**CHANGES FROM BASE PRODUCT VBV-300C-C (5212A) TO VBV-300C-C (CO-DIS) (5728A)**

Assembly PI Approval J. LAM	Approved by B. CHILDS	Checked by J. TYRRELL	Drawn by A. FOSTER
Angle of Projection Third Angle	Units mm	Scale N/A	Released 16/09/20
Status RELEASED	VBV-300C-C (CO-DIS)		
Part No 5728A	BE-004420-00-20

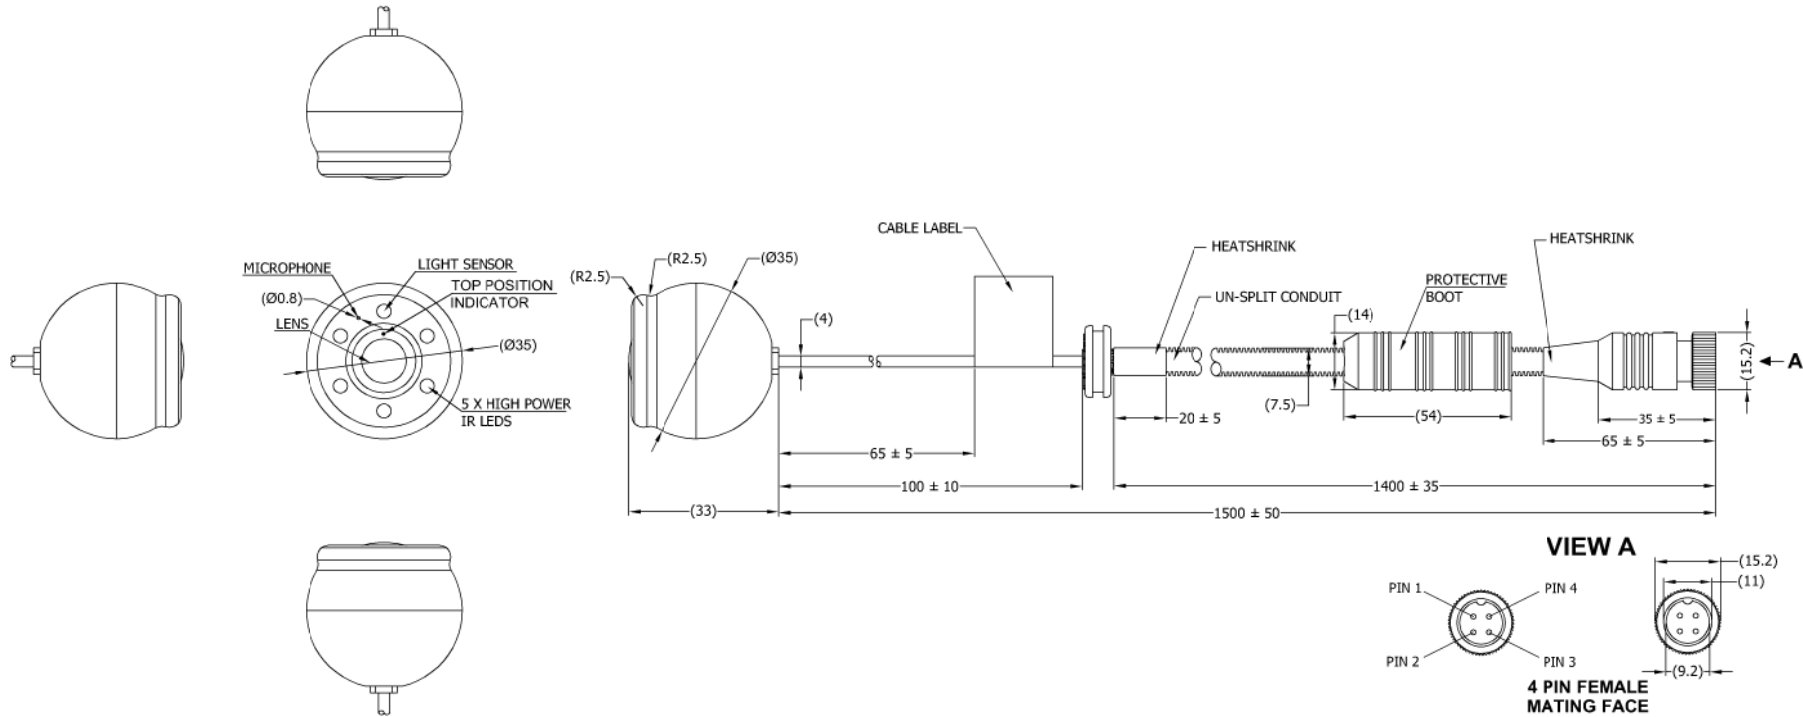
1. CONDUIT ADDED
2. VBV-300C-C CBL-LBL MOVED AND REPLACED WITH VBV-300C-C (CO-DIS) CBL-LBL
3. CABLE LENGTH INCREASED FROM 1000MM TO 1500MM
